Item ID: D412-664-203TRN

Item Name: Crosstube Turning Detail

DART AEROSPACE LTD	Work Order:	88221
Description: Crosstube Assembly (412 High Aft)	Part Number:	D412-664-243
Inspection Dwg: D412-664-243 Rev: E		Page 1 of 2

DRAWING NO. D412-664-243	TITLE CROSSTUBE ASSEMBLY (412 HI AFT)	REV. E	DART AEROSPACE LTD ENGINEERING ORDER		D.E.O. NO. D412-664-243-E-1	SHEET NO. SHEET 1 OF 2	SCALE NTS
DRAWN	CHECKED	MFG. APPR.	APPROVED	DE APPR.			
DATE 11.03.31	DATE 11/03/31	DATE 11.03.31	DATE 11/03/31	DATE 11.03.31

D212-664-243
ASSEMBLY DETAIL

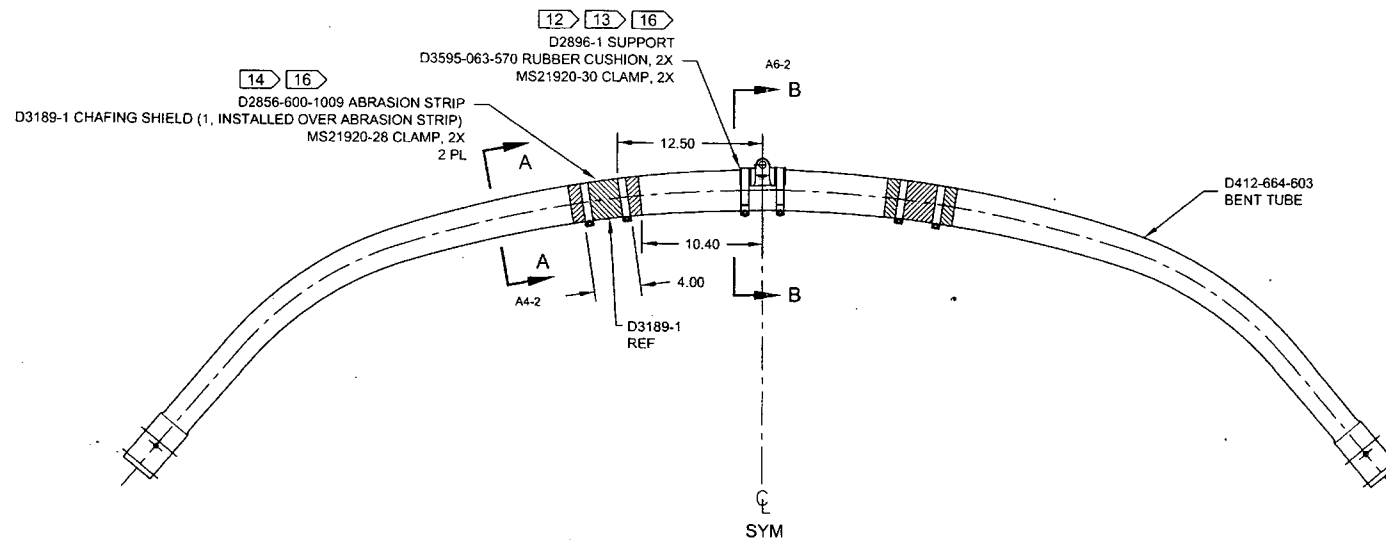
REMOVED ABRASION STRIP IN FAVOR OF A THIN LAYER OF PROSEAL 890.

D2856-600-1009 ABRASION STRIP
D3189-1 CHAFING SHIELD (1, INSTALLED OVER ABRASION STRIP)
MS21920-28 CLAMP, 2X
2 PL

D3189-1 CHAFING SHIELD (1, INSTALLED OVER PROSEAL 890)
MS21920-28 CLAMP, 2X
2 PL

MASK AREA PRIOR TO PAINTING AND
APPLY CLEAR COAT AFTER PAINTING
